State of New Mexico
ENERGY, MINERALS and NATURAL RESOURCES DEPARTMENT
Santa Fe, New Mexico 87505

MEMORANDUM OF MEETING OR CONVERSATION

NMGSAU Battery No. 5

Re: **MONUMENT DISPOSAL SITE**
Final Closure Report
P&A of Monitor Well
Lea County, New Mexico

CROSS-SECTION AT MONUMENT

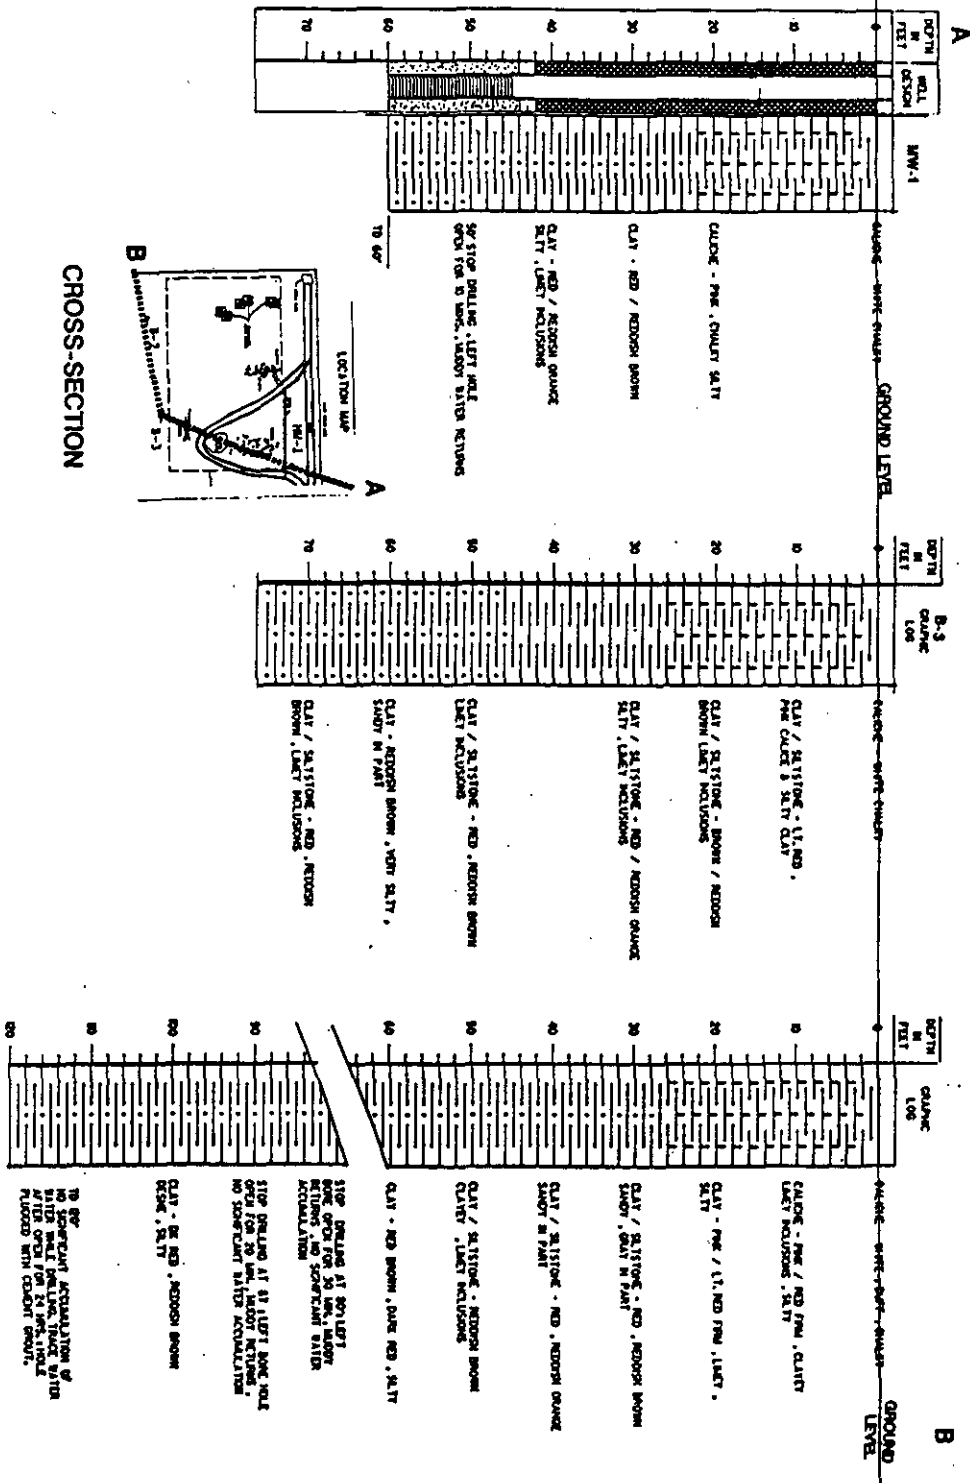
A cross-section constructed from the boring logs appears on the next page. Since there was only a minor relative difference in surface elevations between the borings no corrections were made. The cross-section does not reveal any significant correlation between the borings. There is no correlation of water-

bearing zones between MW-1 and B-2, and B-3. Boring B-3 exhibited the greater sand content but it did not correlate to either of the other borings.
